AGENDA
PARKS, RECREATION & NATURAL RESOURCES COMMITTEE
MEETING

To: Planning Commission
From: Kris Jenson, Planning Manager
Date: September 24, 2024
Subject: Packet Material for the October 3, 2024 Planning Commission Meeting

Crown LMN, LLC has submitted applications and plans for a preliminary plat and conditional use permits for Crown Lakeville Apartments, which proposes one lot and one outlot two multi-family apartment buildings on about 10 acres of land located north of 210th Street (CSAH 70) and west of Keokuk Avenue. The property currently includes a single-family home and is heavily wooded.

SHEET
C3.01
REV.

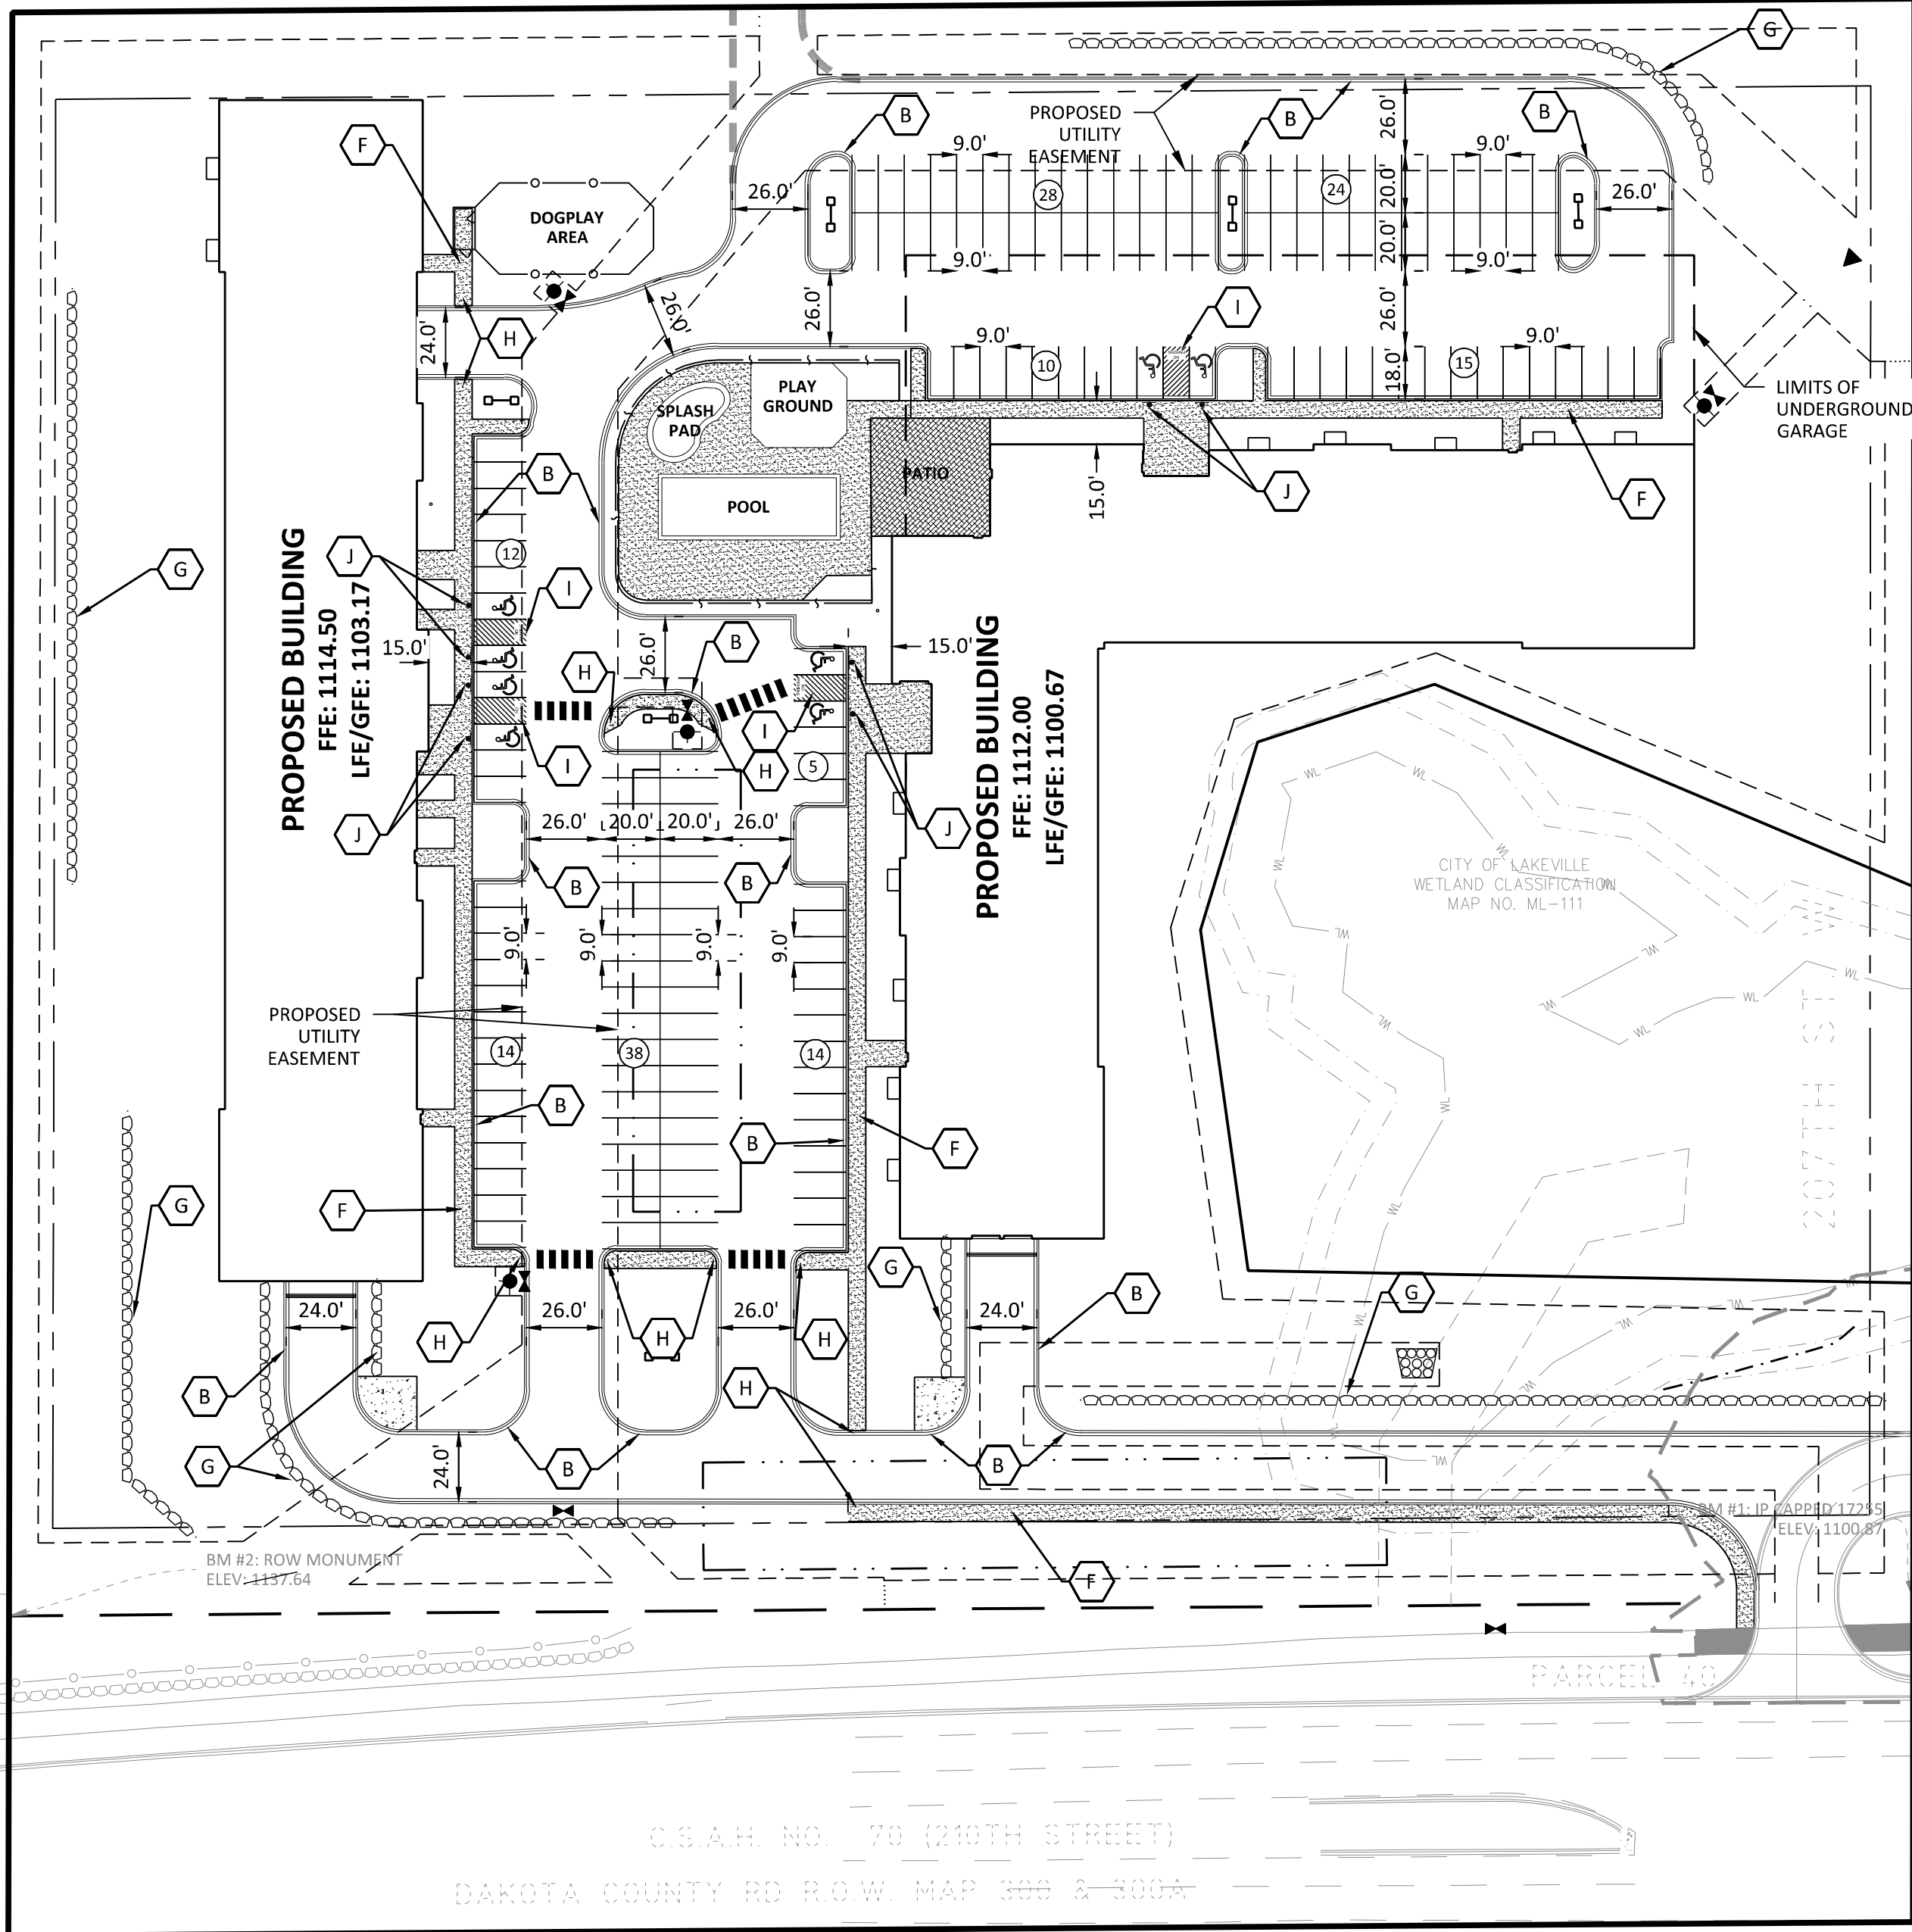
Amenity Area. The site plan indicates an amenity area attached to the east building, which includes a patio, pool, playground, and splash pad and is enclosed with a decorative black metal fence. Section 11-21-5.A of the Zoning Ordinance requires details regarding fencing for the patio and pool area to be submitted for review and approval by the Zoning Administrator, including compliance with Section 11-21-5.G of the Zoning Ordinance related to pools.

SHEET
L-0.01
REV.

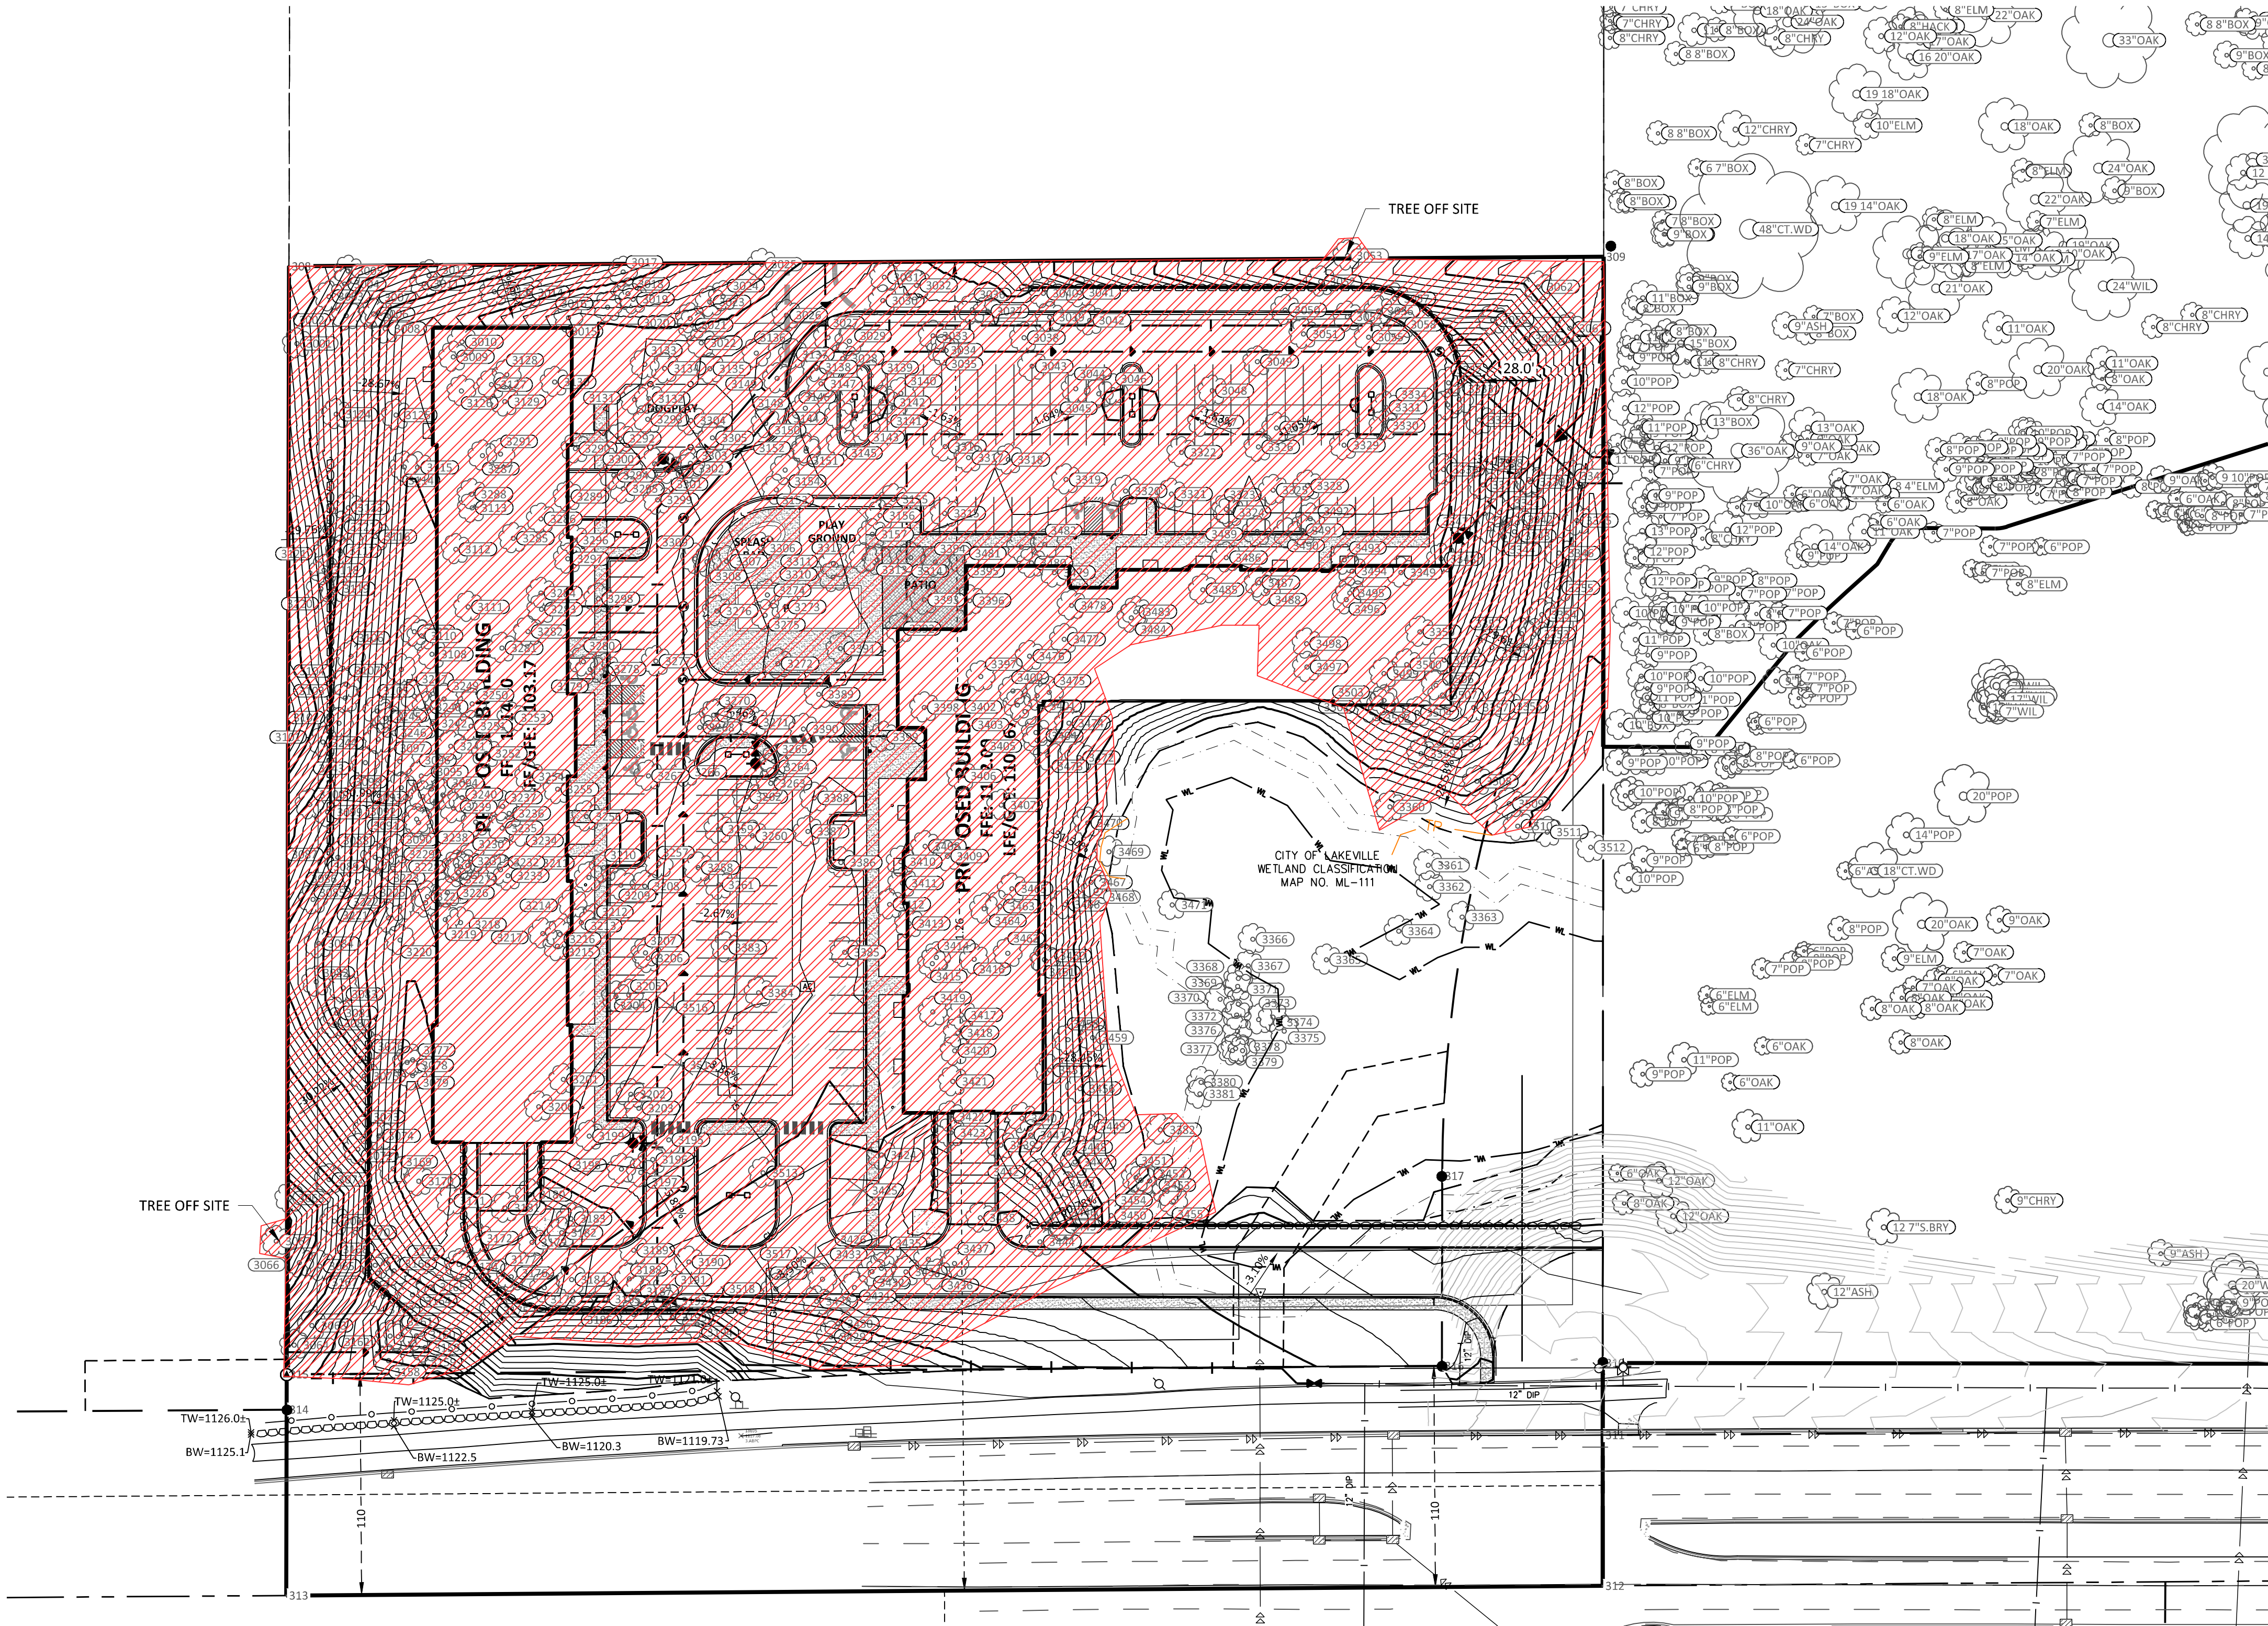
Tree Preservation. The tree preservation plan (Exhibit H) identifies 519 significant trees on the entire 9.94 acre site. Due to the high-density residential development proposed, 495 trees (4.6%) will be removed with the residential development, with 24 trees remaining, most all of which are within the wetland on site. See the September 24, 2024 Engineering report for additional information.
